March 5, 2010

DOMINION NUCLEAR CONNECTICUT, INC.
MILLSTONE POWER STATION UNIT 3
RESPONSE TO QUESTIONS 28 AND 30 OF REQUEST FOR ADDITIONAL
INFORMATION REGARDING A SPENT FUEL POOL CRITICALITY LICENSE
AMENDMENT REQUEST

RESPONSE TO RAI QUESTIONS 28 AND 30
REGARDING THE SPENT FUEL POOL CRITICALITY LICENSE AMENDMENT
REQUEST

Figure 2 – Minimum Required Fuel Assembly Burnup versus Initial ²³⁵U Enrichment for the “Region 2” Storage Configuration

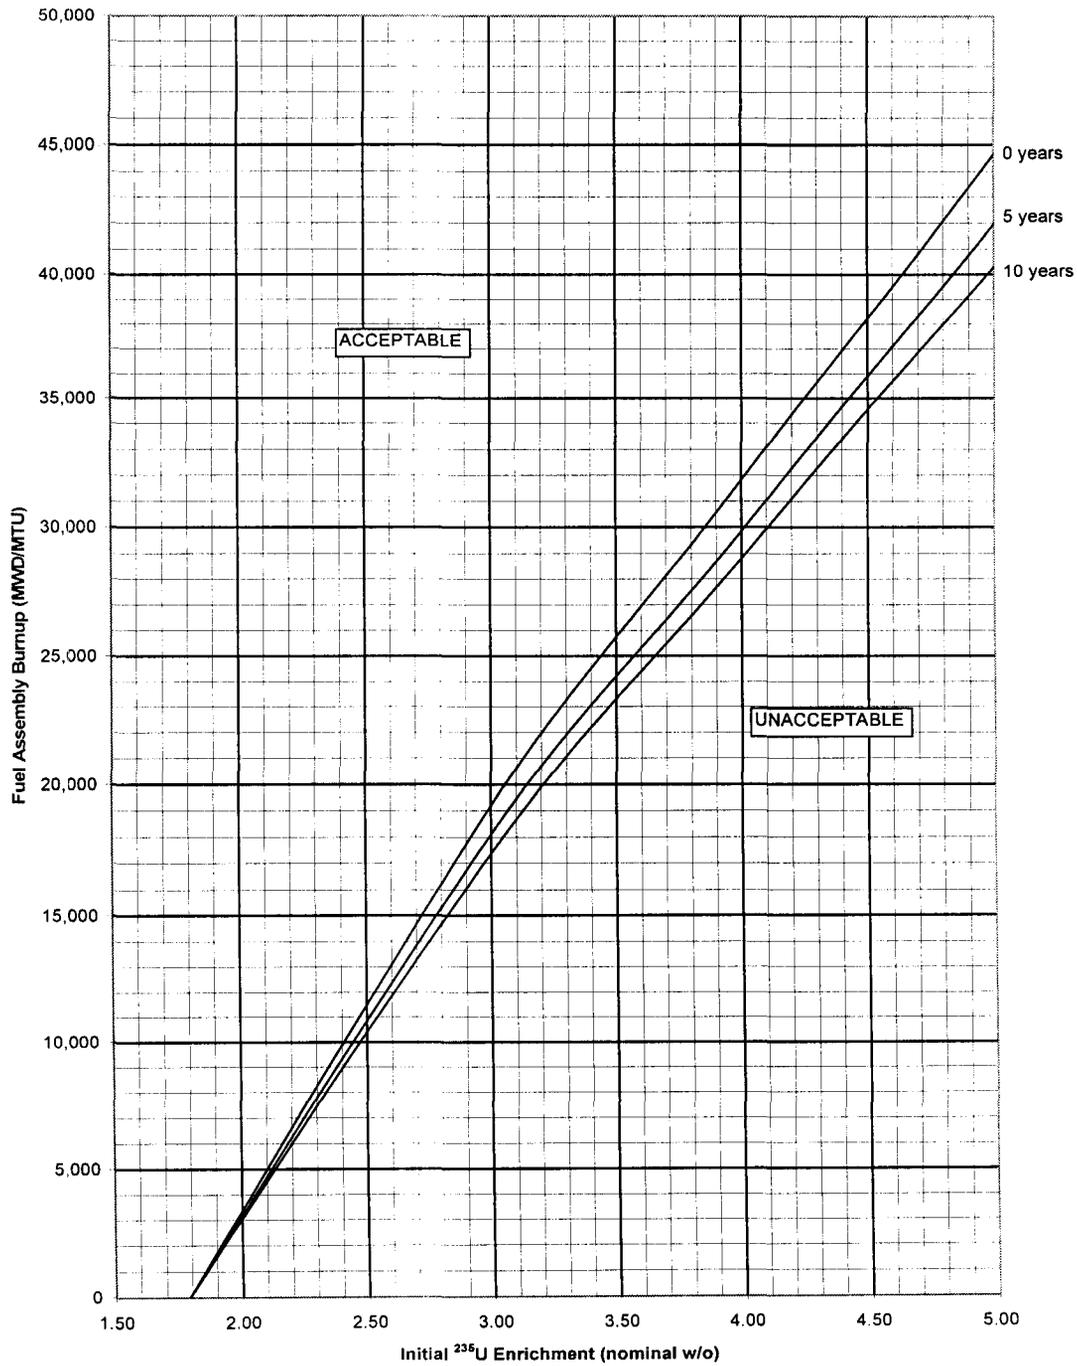
Please verify the average core exit temperature for nominal reactor coolant system (RCS) flow. Please verify the maximum core exit temperature for the minimum TS allowed RCS flow. Please provide the maximum fuel assembly exit temperature for the minimum TS allowed RCS flow. Please provide the moderator temperature used for each case in the RAI #21 responses.

The burnup versus enrichment curves provided in response to this RAI completely supersede the burnup versus enrichment curves previously provided. Tables 16 and 17 and Figures 2 and 3 show the new burnup versus enrichment curves. The calculations supporting these curves have been performed with conservatisms including high temperature, high soluble boron, maximum IFBA loading, higher than credible fuel density, and with the most conservative applicable burnup profile. In addition, allowances for depletion power history uncertainty, burnup worth uncertainty, and measured burnup uncertainty are conservatively treated as biases, and administrative

margin is increased to 0.5% Δk. These factors provide assurance that the storage requirements presented in Tables 16 and 17 and Figures 2 and 3 are conservative.

NOTE: For assemblies from Post-Uprate (3650 MWt) Cores, the nominal fuel enrichment of blankets must be ≤ 2.6 wt% U-235, and nominal blanket length must be at least 6 inches on both ends of the fuel. Fuel batches A, B, C, and D may not be stored in Region 2.

Figure 3.9-3 Minimum Fuel Assembly Burnup and Decay Time Versus Nominal Initial Enrichment for Region 2 Storage Configuration

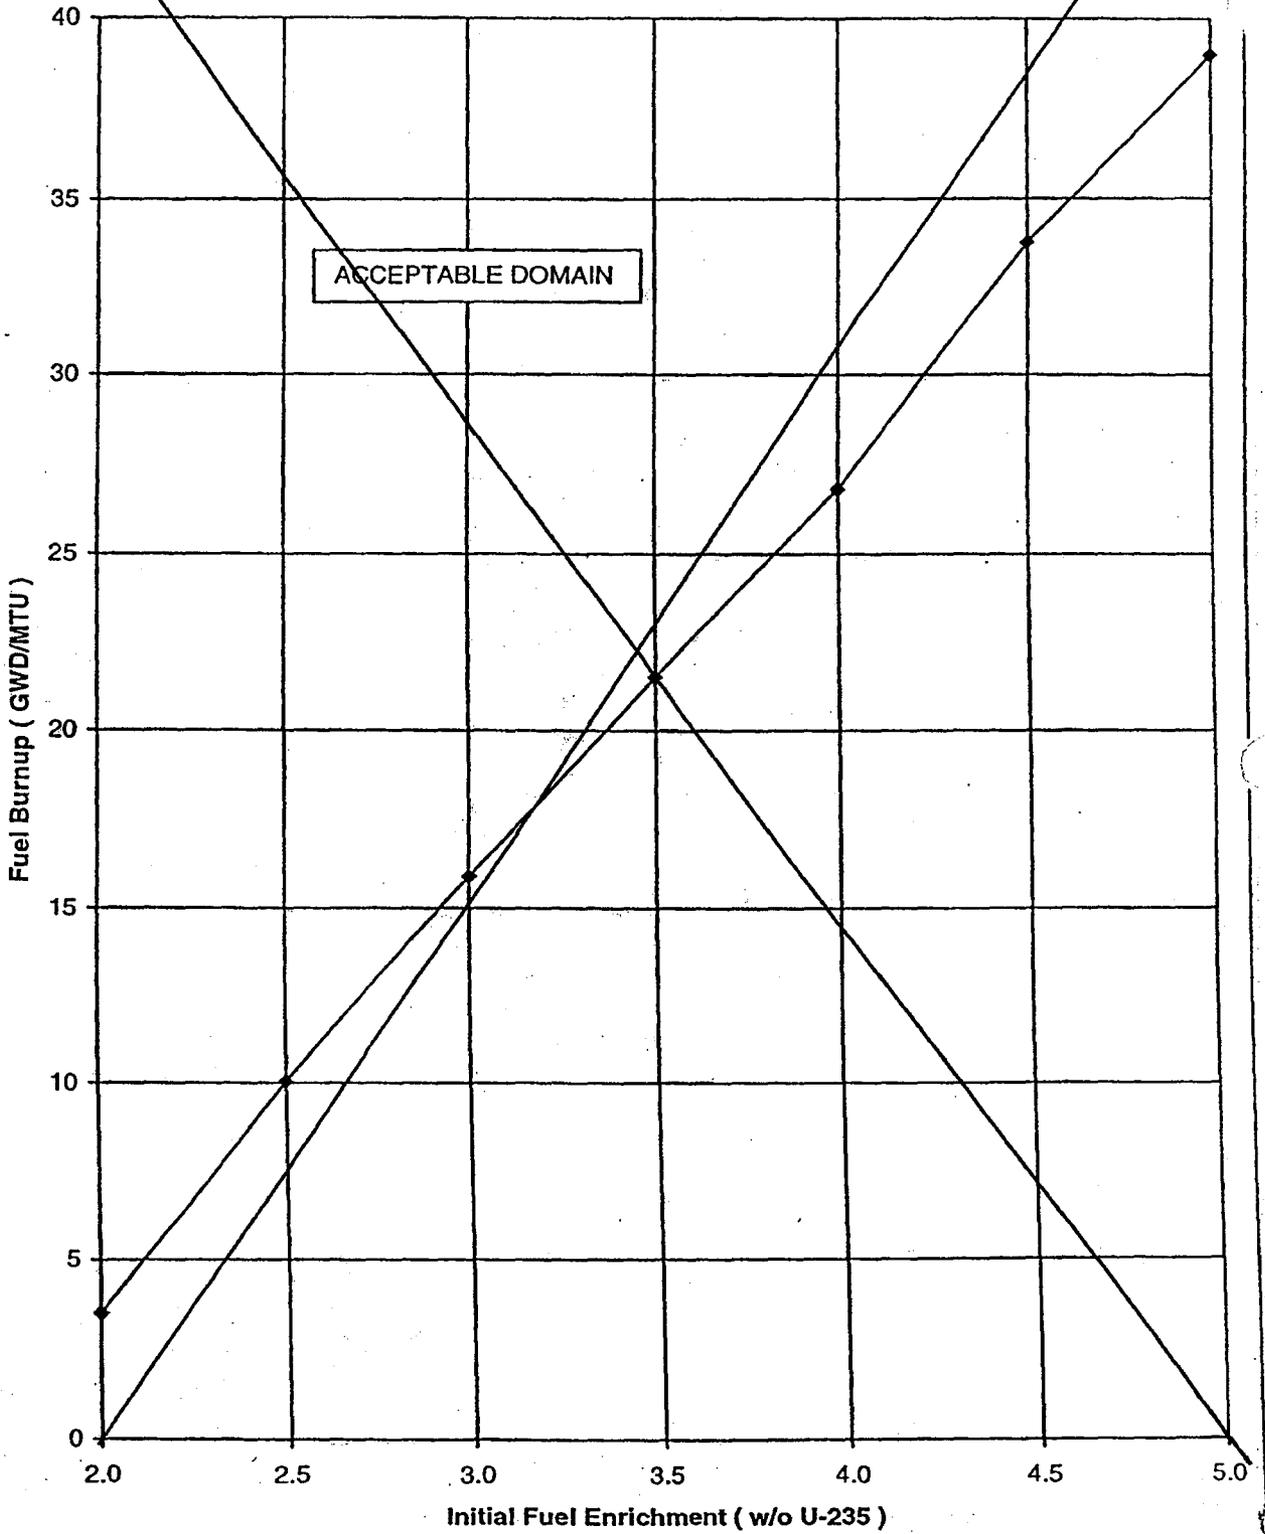
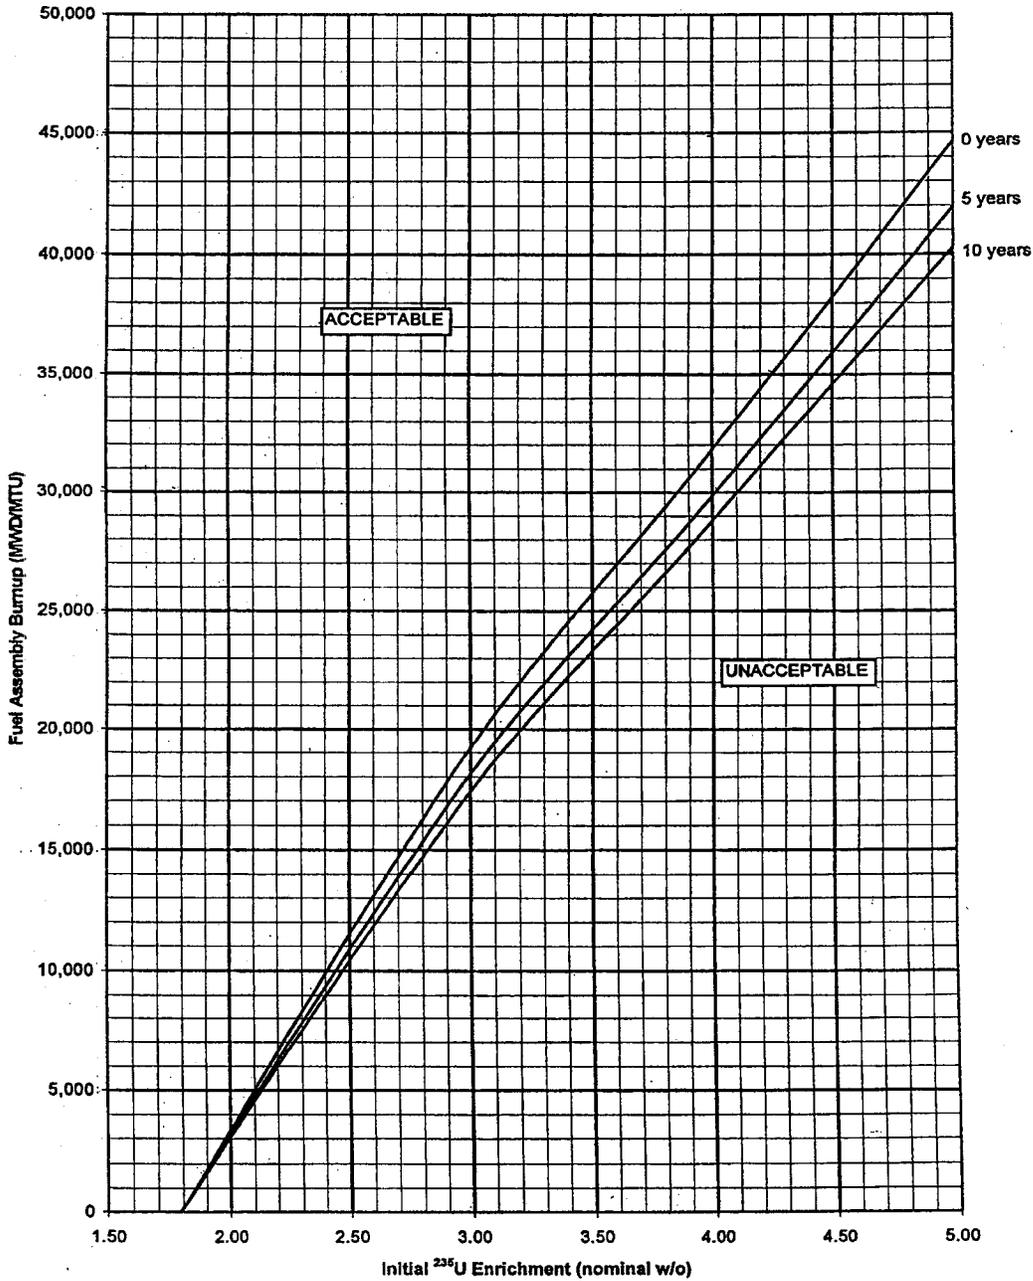
FIGURE 3.9-3 Minimum Fuel Assembly Burnup Versus Nominal Initial Enrichment for Region 2 Storage Configuration

Replace with next page

NOTE: For assemblies from Post-Upgrade (3650 MWt) Cores, the nominal fuel enrichment of blankets must be ≤ 2.6 w/o U-235; and nominal blanket length must be at least 6 inches on both ends of the fuel. Fuel batches A, B, C, and D may not be stored in Region 2.

Figure 3.9-5 Minimum Fuel Assembly Burnup and Decay Time Versus Nominal Initial Enrichment for Region 3 Storage Configuration for Assemblies from Post-Uprate (3650 Mwt) Cores

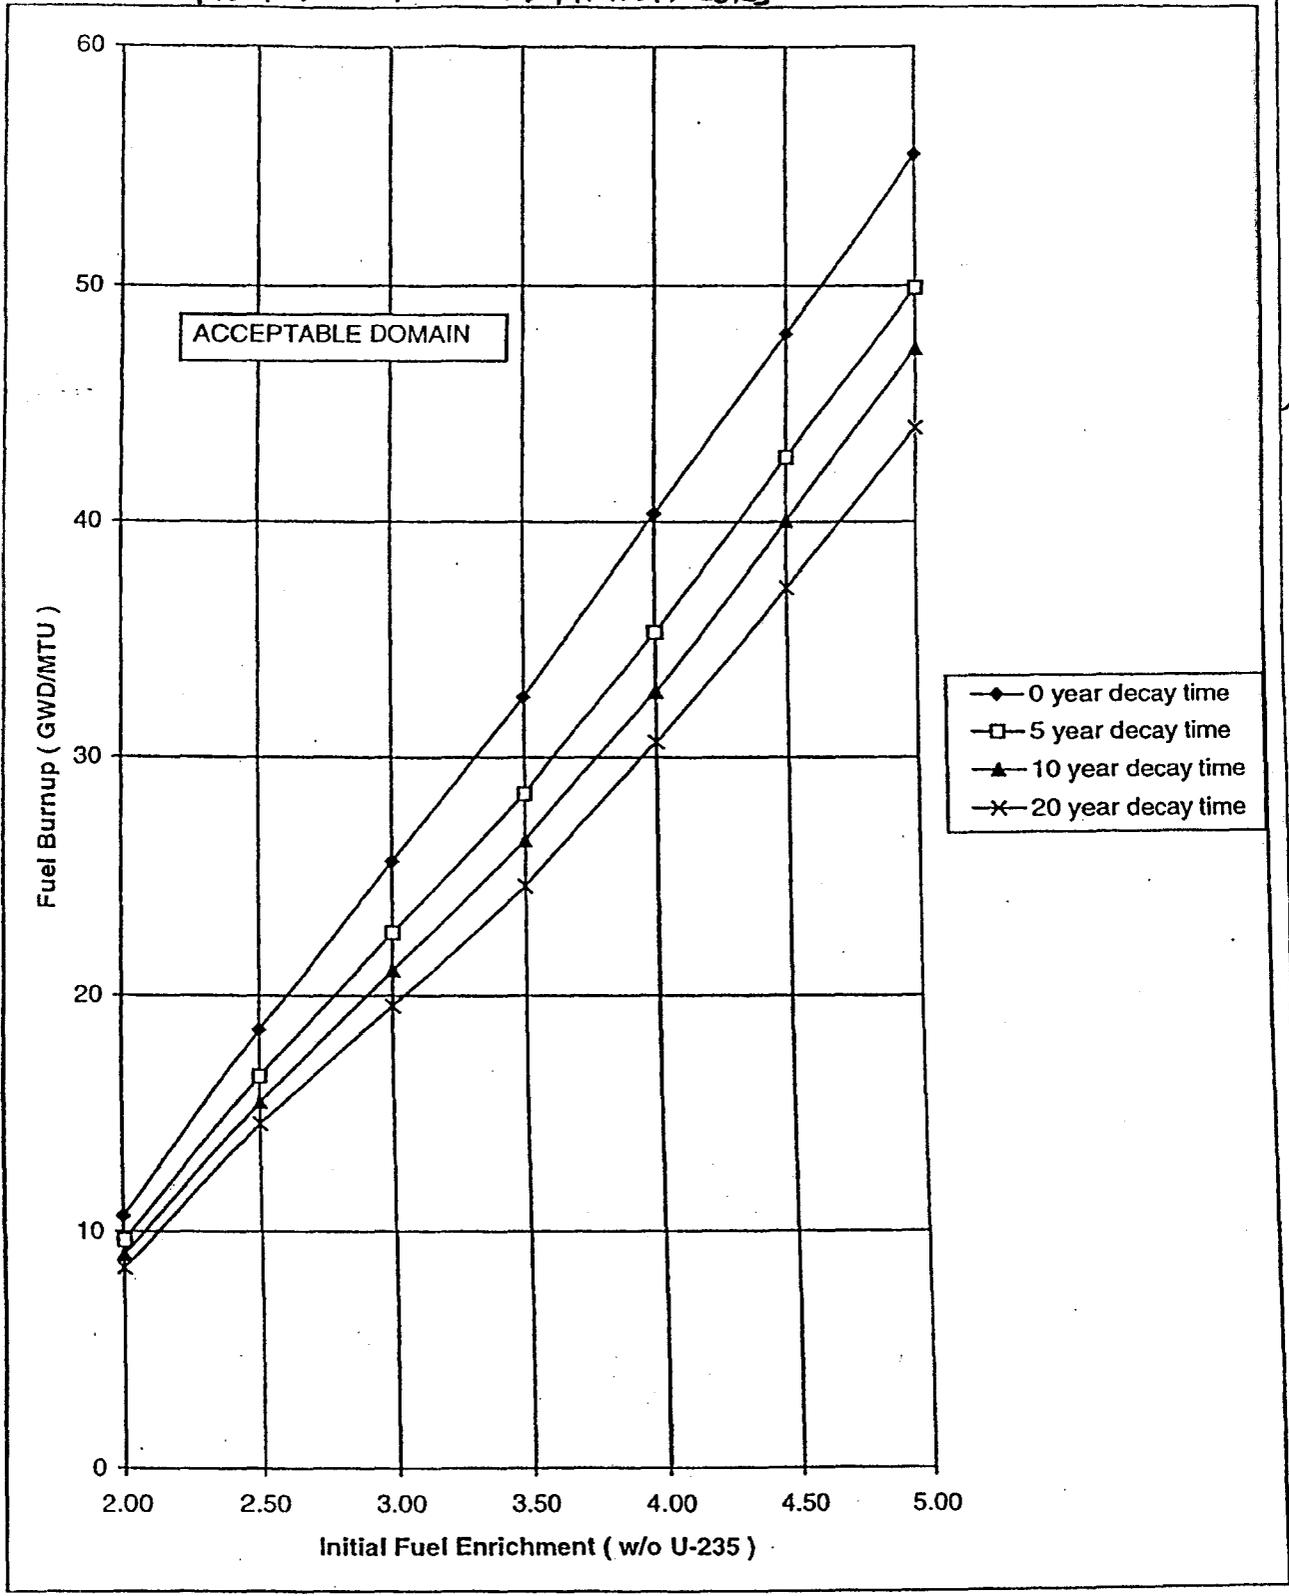
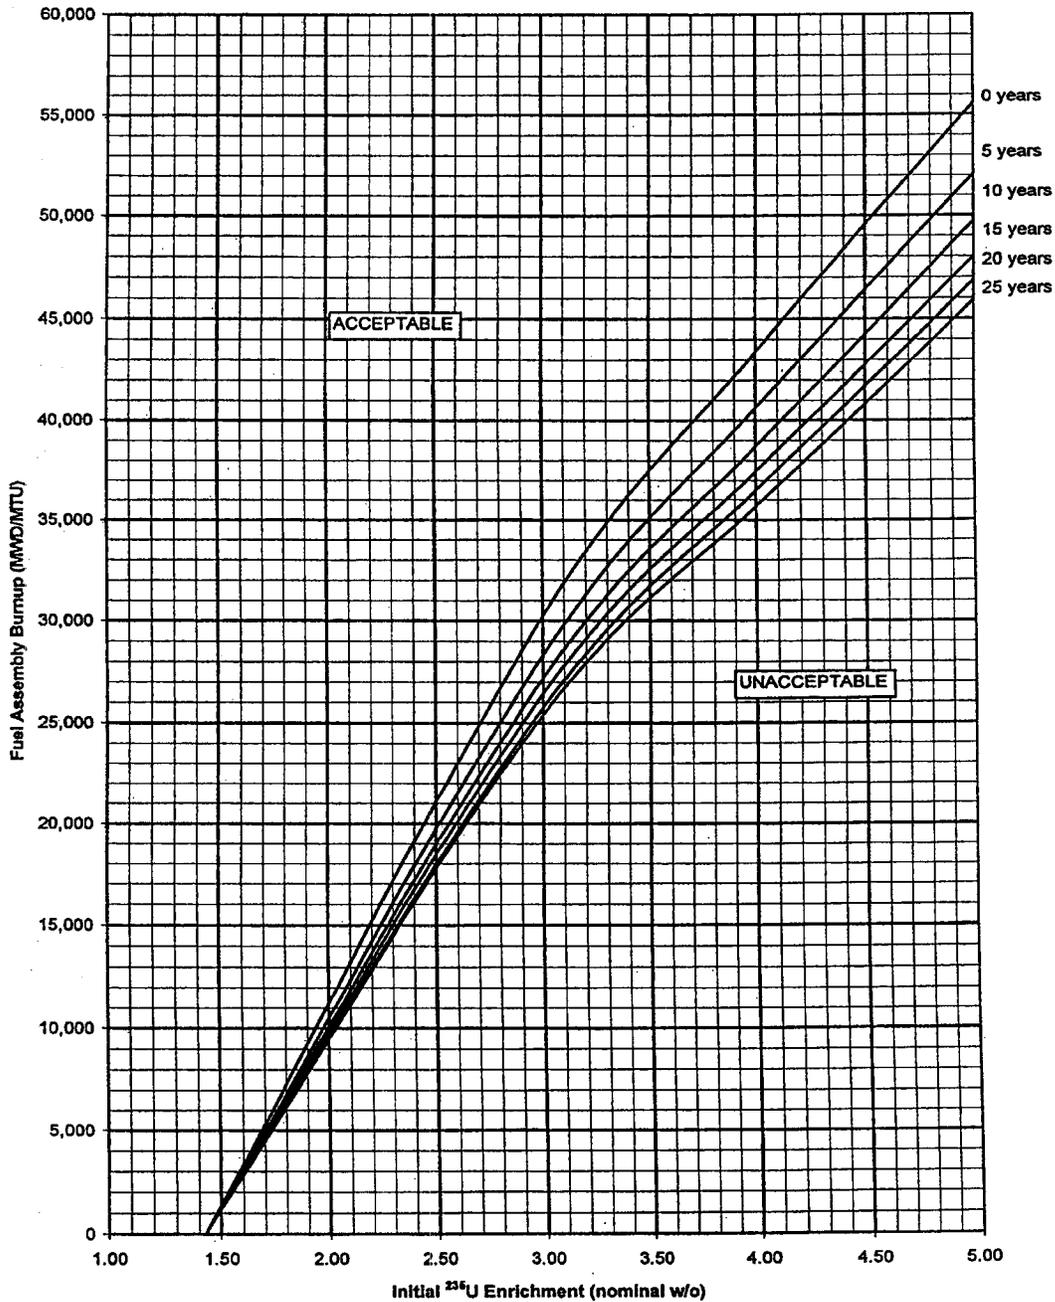
FIGURE 3.9-4 Minimum Fuel Assembly Burnup and Decay Time Versus Nominal Initial Enrichment for Region 3 Storage Configuration For assemblies from pre-uprate (3411 MWt) Cores

NOTE: For assemblies from Post-Uprate (3650 MWt) Cores, the nominal fuel enrichment of blankets must be ≤ 2.6 w/o U-235, and nominal blanket length must be at least 6 inches on both ends of the fuel.
